Office Action Summary	Application No. 10765,582	Applicant(s) TOTH ET AL.	
	Examiner Chih-Cheng Glen Kao	Art Unit 2882

DETAILED ACTION

TITLE: SYSTEM AND METHOD OF X-RAY FLUX MANAGEMENT CONTROL

FIG. 14

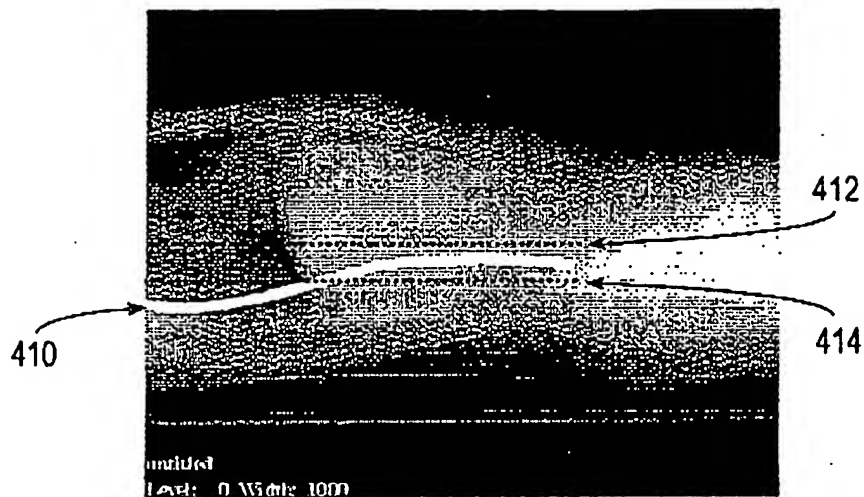
1. The drawings are objected to because the contrast in Figures 14 and 15 make them difficult to see.

Corrected drawing sheets in compliance with 37 CFR 1.121(d) are required in reply to the Office action to avoid abandonment of the application. Any amended replacement drawing sheet should include all of the figures appearing on the immediate prior version of the sheet, even if only one figure is being amended. The figure or figure number of an amended drawing should not be labeled as “amended.” If a drawing figure is to be canceled, the appropriate figure must be removed from the replacement sheet, and where necessary, the remaining figures must be renumbered and appropriate changes made to the brief description of the several views of the drawings for consistency. Additional replacement sheets may be necessary to show the renumbering of the remaining figures. Each drawing sheet submitted after the filing date of an application must be labeled in the top margin as either “Replacement Sheet” or “New Sheet” pursuant to 37 CFR 1.121(d). If the changes are not accepted by the examiner, the applicant will

FIG. 18

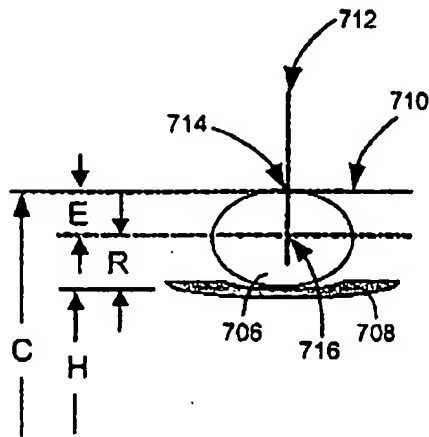
The drawings are also objected to because of the following: (equation “ $E=R+H-C$ ”, as defined on page 27, first paragraph, fails to correspond to fig. 18) and (equation “ $E=C-R-L$ ”, as defined on page 27, second paragraph, fails to correspond to fig. 19). The equation “ $E=R+H-C$ ” is equivalent to $E+C=R+H$. However, as seen in Figure 18, $E+C$ fails to equal $R+H$. Likewise, the equation “ $E=C-R-L$ ” is equivalent to $E+R+L=C$. However, as seen in Figure 19, $E+R+L$ fails to equal C .
